A417 Missing Link

Cotswolds Conservation Board - Options Report

HE551505-ARP-HGN-X_XX_XXXX_X-RP-C-000005

Figure 5-1 CCB Birdlip Bypass

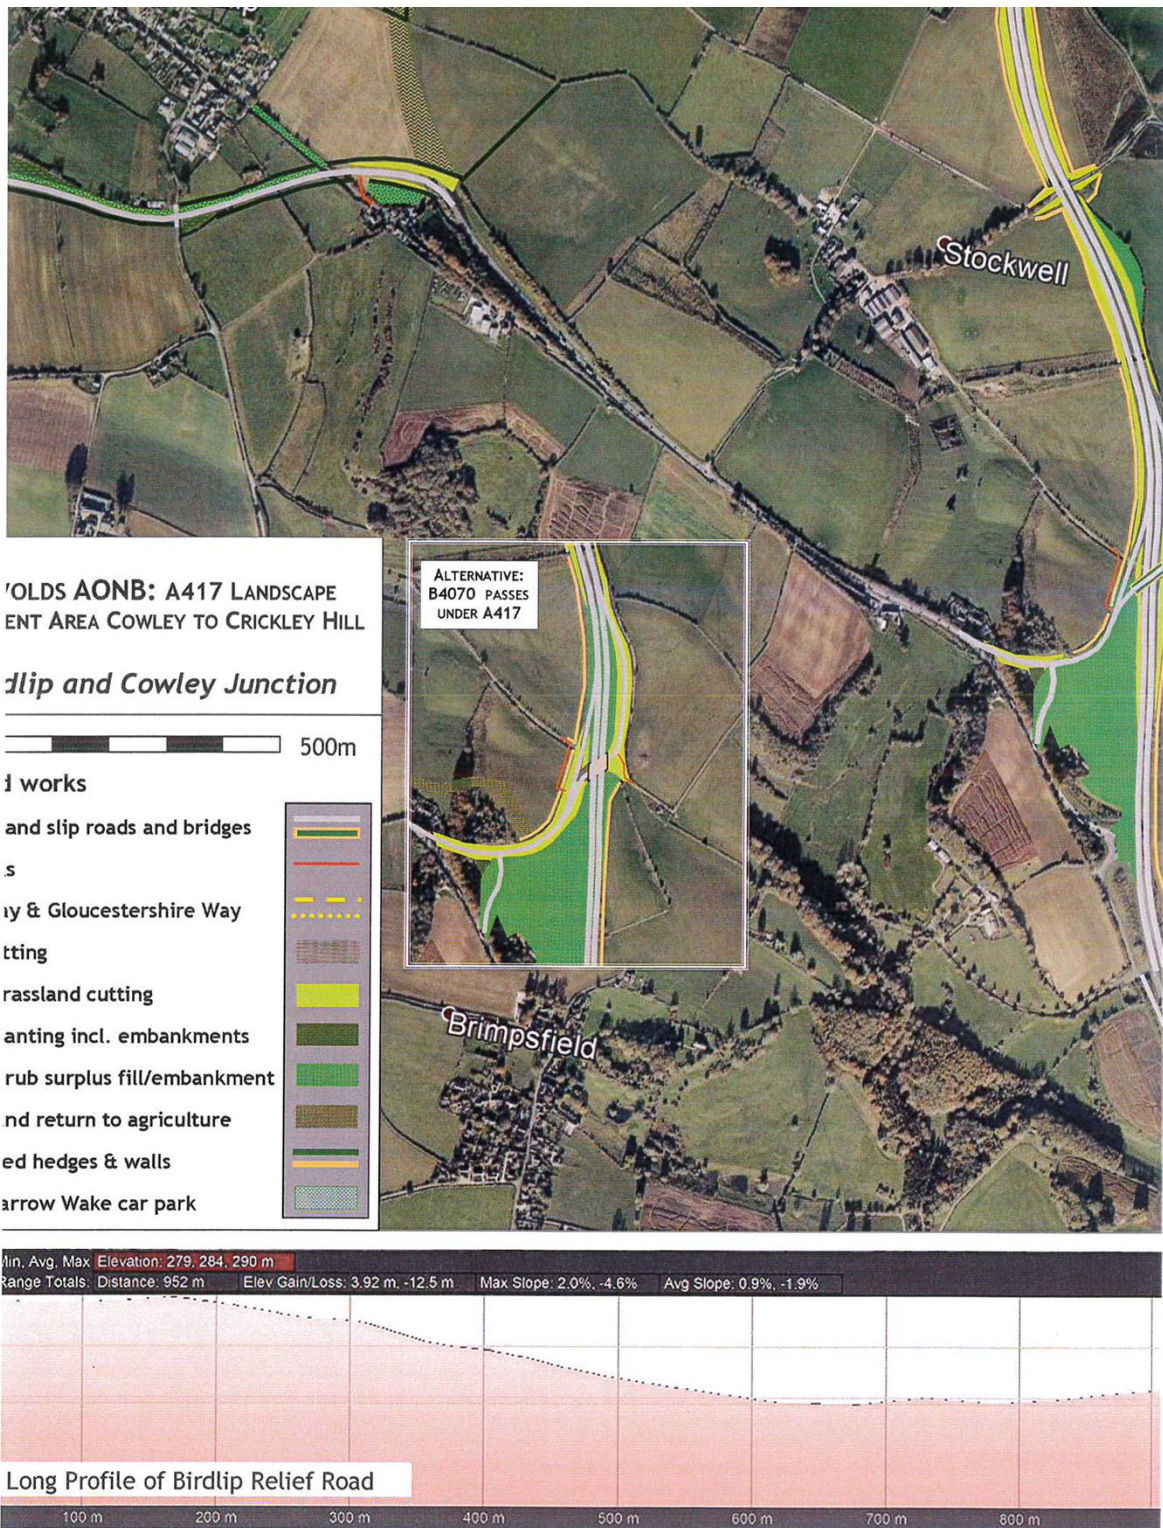
- pass to the south of the village:
- be single carriageway road similar in character to existing local roads in terms of verges and landscaping
- follow the existing ground level at grade.
- Incorporate at grade crossroads and T junctions at minor roads (or mini roundabouts if essential).
- topsoil mounding to the north as noise barrier and limestone grassland and avoiding off site spoil disposal.
- minor planting in severed corners of fields.
- Shab Hill junction would be amended to remove the current Birdlip link road.

- Traffic through the centre of Birdlip would be reduced significantly
- Noise and air pollution levels in Birdlip would be reduced
- Quality of life in Birdlip would be enhanced
- a significant landscape and environmental gain in the wider landscape by not having the link route across to Shab Hill
- The Shab Hill junction arrangement would be simpler, freer flowing and delivered at a reduced cost
- Journey time would be the same or better than the current proposed route in Option 30 to Shab Hill

Figure 5-2 Indicative Plan of CCB Overall Proposals

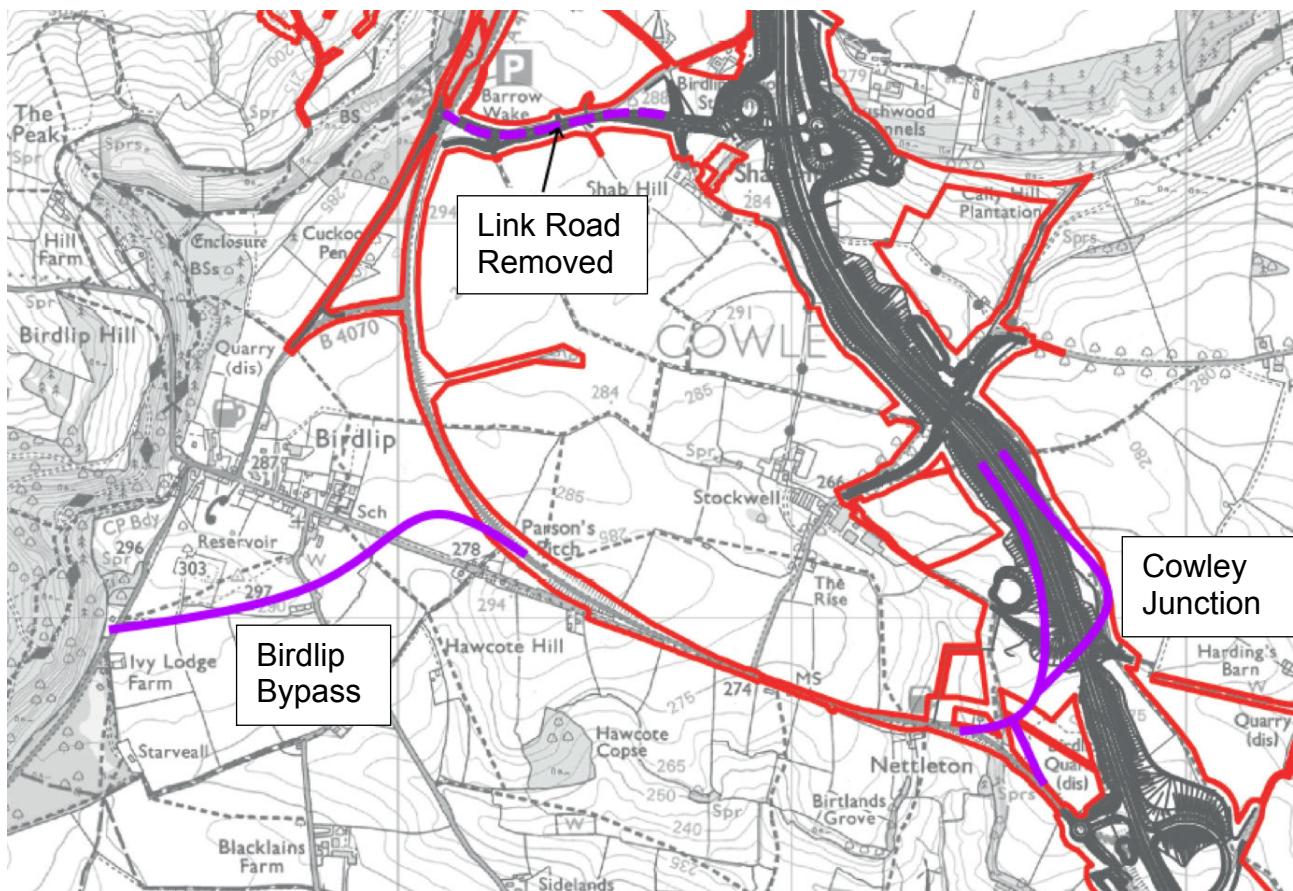
- 5.3.2 Local journeys between Birdlip and Cheltenham currently use the existing B4070 and A417 via the Air Balloon roundabout.
- 5.3.3 To limit the adverse effect on local journeys, connectivity routes would generally need to be as close to the existing Air Balloon Roundabout as possible and continue to offer access to all current directions.

- 5.3.4 Shab Hill junction would provide this connectivity. It is grade separated and would include four slip roads offering full access to the A417 in both directions. It would also provide connectivity between Cheltenham and Birdlip via the underbridge and A436 link road.

- 5.3.5 Removing the western connection from Birdlip to Shab Hill junction would mean that northbound/westbound traffic from the B4070 Birdlip area would need to travel via Birdlip bypass and the Cowley junction which would add approx. 2.8km to the journey

- 5.3.6 Similarly removing the west connection to Shab Hill junction would mean that eastbound traffic from the B4070 Birdlip area would need to travel via the Cowley junction and use the new A417 to travel north and turn around a Shab Hill approx. 3.2km to the journey.

- 5.3.7 A modification to include a westbound diverge and eastbound merge would remove the 3.2km detour, however, this would be at additional cost and have more environmental impact.

- 5.3.8 It is concluded this proposal would increase journey times and would likely reduce the BCR.

Figure 5-4 Outline Design of CCB Birdlip Bypass Proposal (Profile)

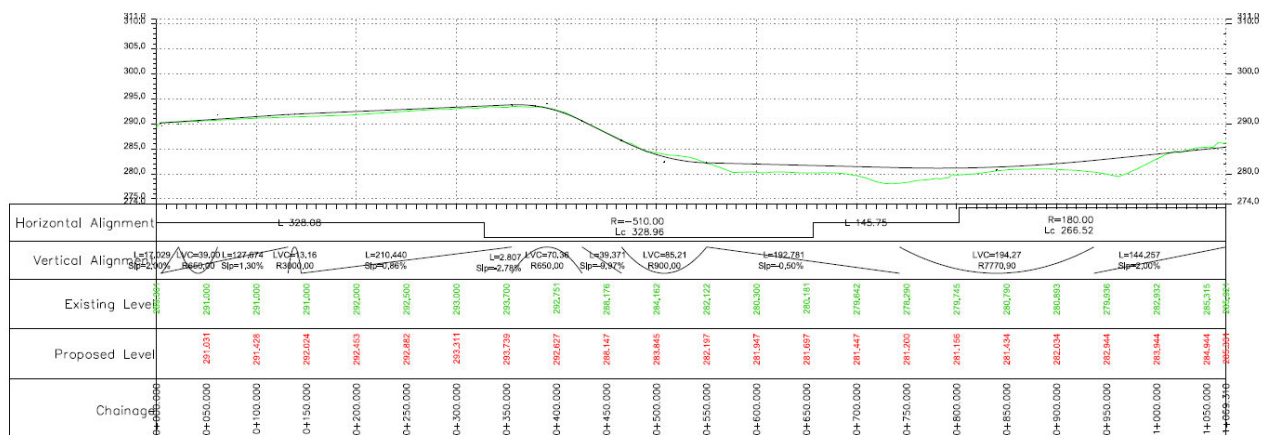
- 5.3.9 To evaluate the proposals an outline design of the suggested alignment for the Birdlip bypass was undertaken. These are indicated in Figure 5-1 and Figure 5-3.

- 5.3.22 Overall, the route would present alignment challenges both horizontally and vertically to achieve a safe and compliant design. The horizontal and vertical curvature required to follow the suggested route would require several Departures from Standard (DfS) which would require justification in terms of safety.

5.3.25 Table 5-1 indicates the number of relaxations required to achieve the CCB alignment. These would in most cases represent Departures from Standard however certain amendments to the design could be made to reduce them however that would involve introducing large cuttings or embankments and wide verges to improve visibility.

Figure 5-5 Example of Mini Roundabout

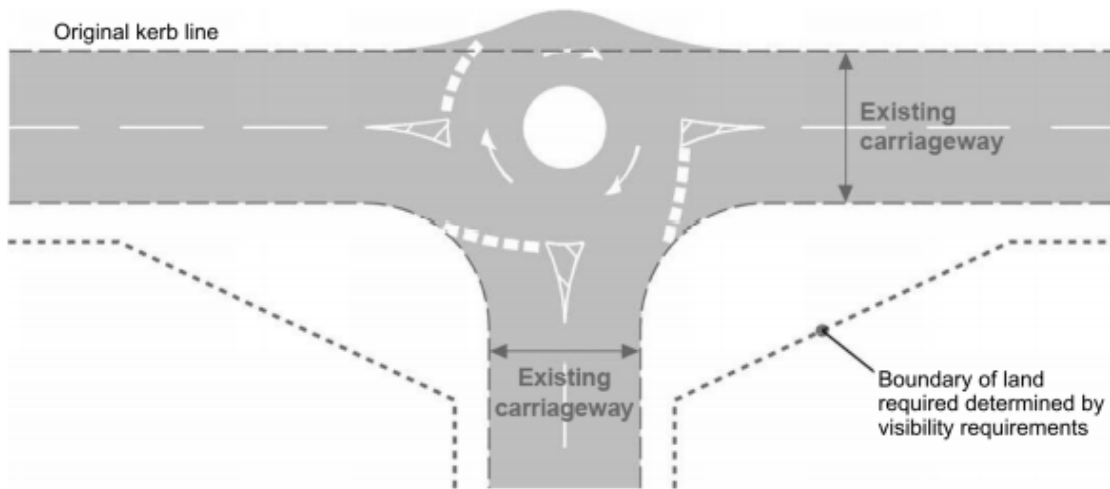
- 5.3.17 The suggestion of mini roundabouts such as those indicated in Figure 5-5 is noted however these are only permitted in urban settings where the speed limit is less than 30mph.

- 5.3.18 A smaller normal roundabout would be more appropriate in rural settings however this would have a larger footprint and associated impact.

Figure 5-8 2019 B4070 Link Road compared to revised 2020 proposals

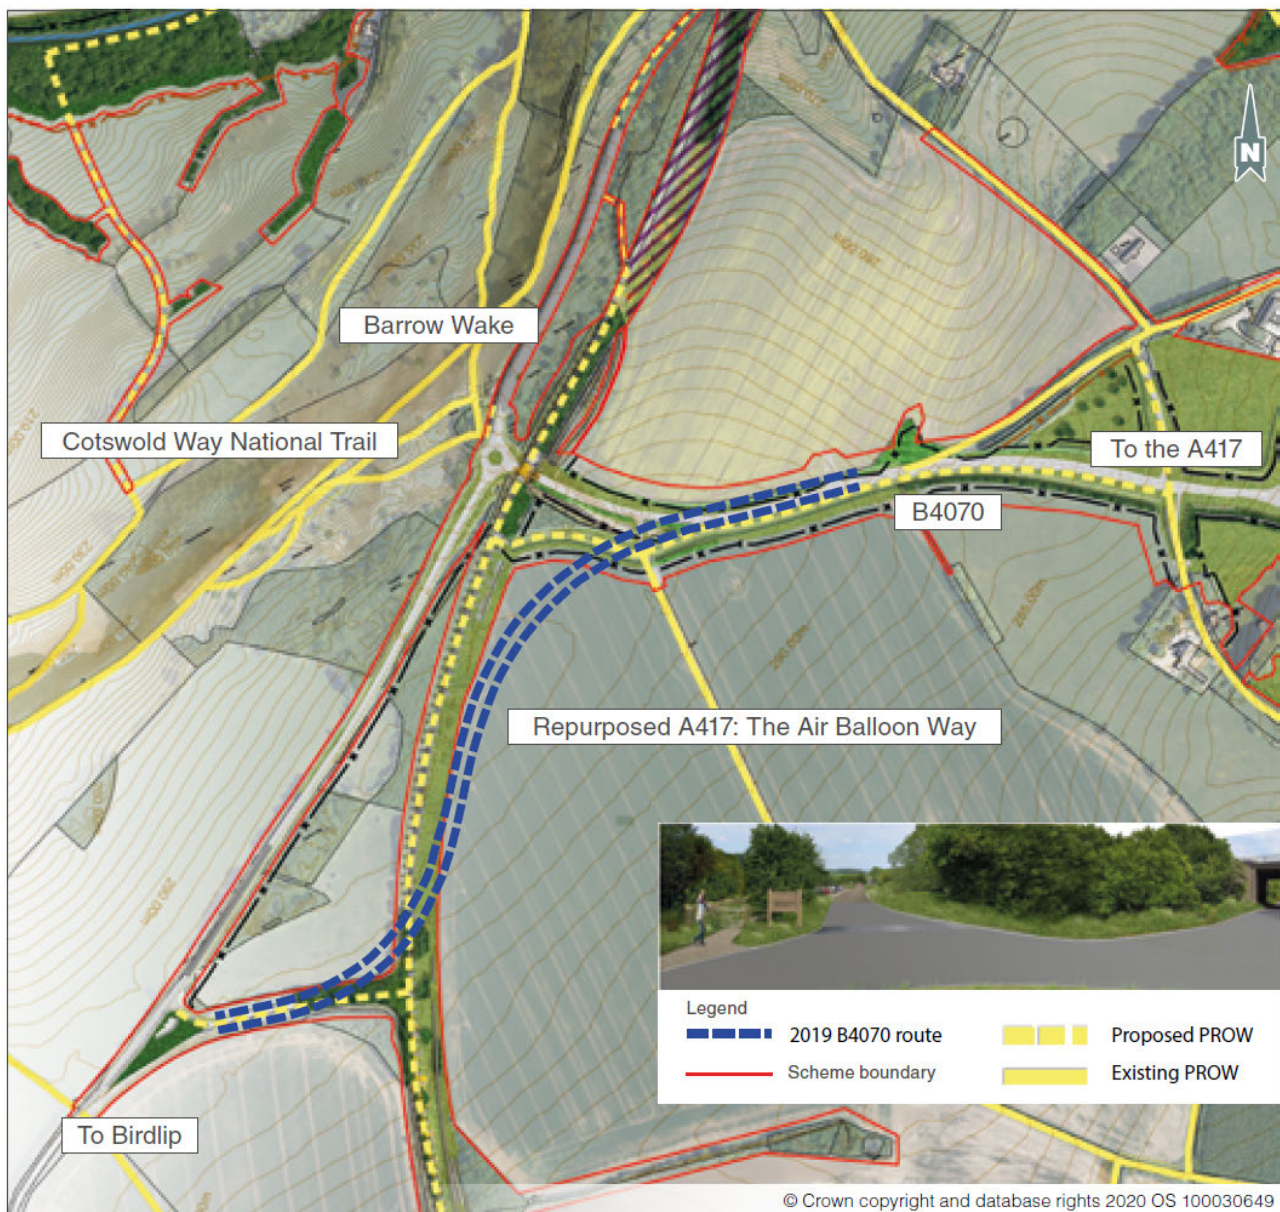
- 5.3.38 During the scheme 2019 consultation there were several objections to the route of the B4070 Birdlip link road presented including opposition of several landowners.
- 5.3.39 There were also calls to improve facilities, parking and accessibility at Barrow Wake and concerns about the proposed alignment of the B4070, which crossed the repurposed A417, and resulted in the loss of agricultural land. There were also concerns expressed regarding antisocial behaviour at Barrow Wake. CCB also objected to the affect the route would have an adverse effect on the High Wold
- 5.3.40 As a result of discussions with Gloucestershire County Council several amendments have be made to the B4070 link road.
- 5.3.41 The original proposals presented at the public consultation in Autumn 2019 provided a link which would cross the fields and tie in to the existing Birdlip junction. See Figure 5-8.

5.3.42 The revised alignment would follow the existing single track alignment and use the existing underpass near Barrow Wake to connect to the original alignment of the A417. This has several advantages:

- Removes the need for a Walking, Cycling and Horse-Riding crossing on the repurposed A417
- Helps regulate traffic speed on B4070
- Provides natural surveillance of Barrow Wake car park, helping to manage antisocial behaviour
- Discourages use by large goods vehicles
- Reduces visual intrusion across the high wold
- Reduces land take.
- Utilises existing infrastructure.
- 600m less additional carriageway

Figure 6-1 CCB Alternative Shab Hill Junction Arrangement and A436 Alignment

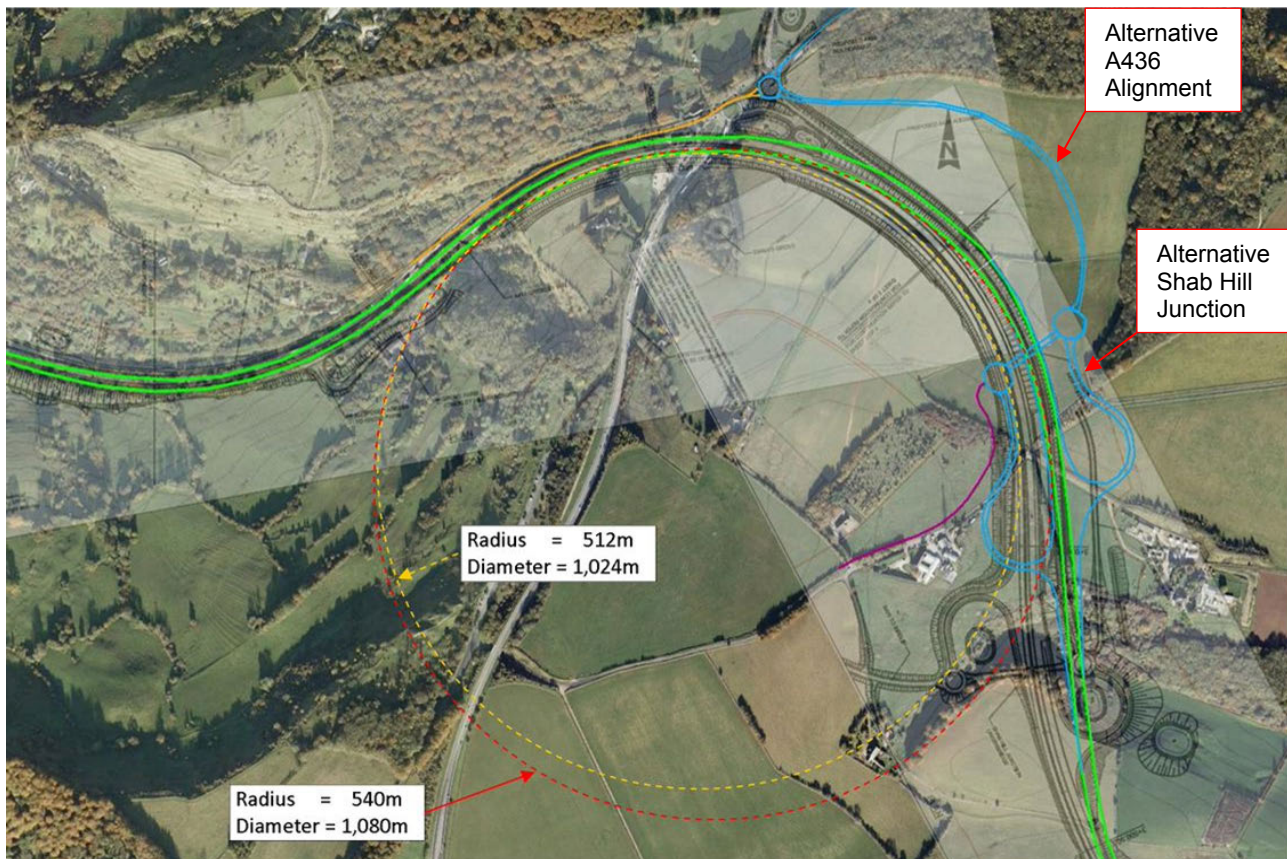
- 6.1.1 CCB recommended that Highways England considered relocating the proposed Shab Hill junction a few hundred metres further north. See Figure 6-1

- 6.1.2 CCB suggested that the A436, the roundabouts and the road connecting the roundabouts could generally be close to existing ground levels, with the A417 passing underneath in the cutting (and emerging not much above ground level at the dry valley where the Shab Hill junction is currently proposed)

- 6.1.3 CCB believed that this design option would significantly reduce visual and noise intrusion at Shab Hill Farm and Rushwood Kennels; noise pollution and visual impacts on the wider landscape; and adverse impacts on the head of the Upper Churn Valley. It would also allow for shallower gradients of the A417 and for the Gloucestershire Way to more closely follow its current route and provide a more pleasant walking experience on this route.

Figure 6-3 Outline Design Layout of CCB Proposals.

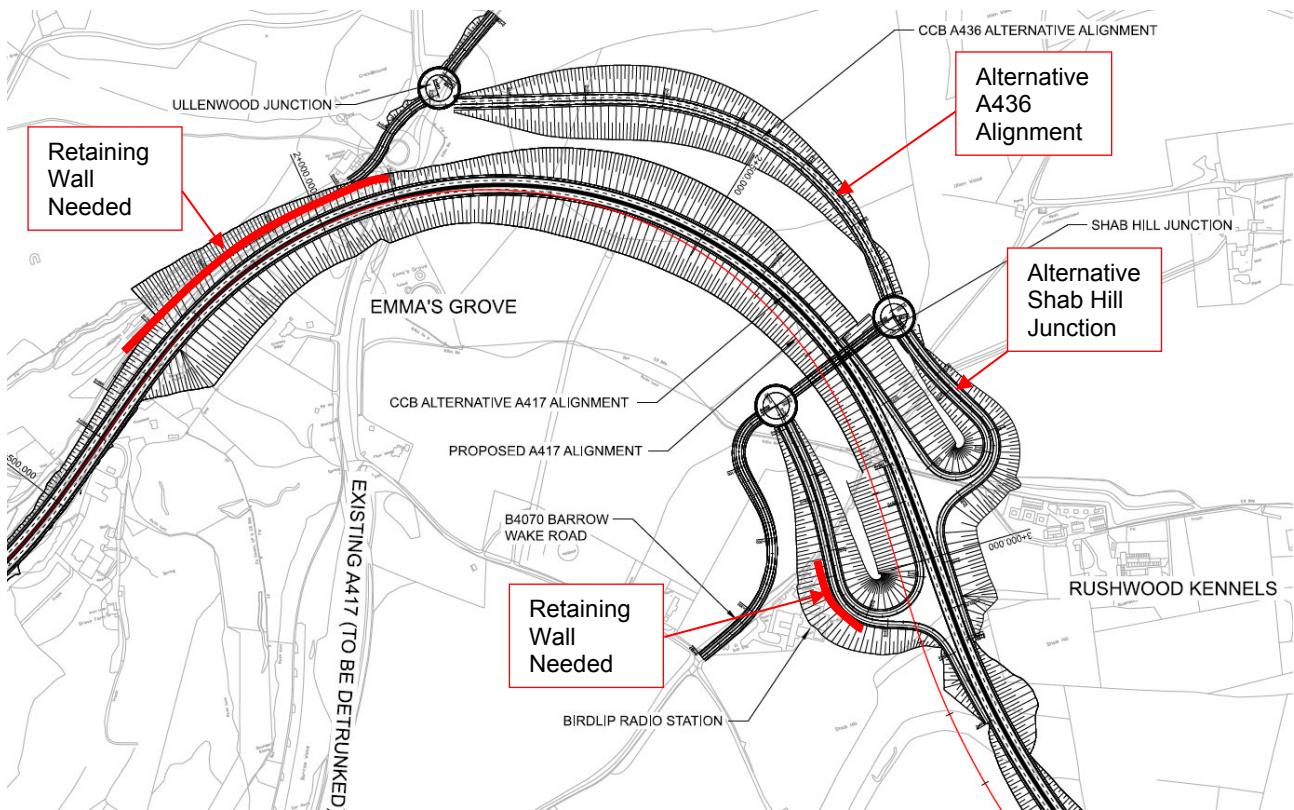
- 6.4.19 The extent of the cuttings required is demonstrated in Figure 6-3 and Figure 6-4. Whilst there would be options to reduce the extent of the earthworks this would likely involve retained earthwork solutions and/or engineered slopes. Indicative locations for most likely retaining wall requirements are shown in Figure 6-3.
- 6.4.20 Whereas the 2020 (8%) scheme proposals now offer a scheme balance of earthworks the proposed alternative offered by CCB would be worse than the 2019 (7%) route and result in a net export of material in excess of 1 million m² due to the increased cut in the vicinity of Shab Hill junction and the realignment of A436 which would require a separate cut. This would have an associated environmental and cost impact.
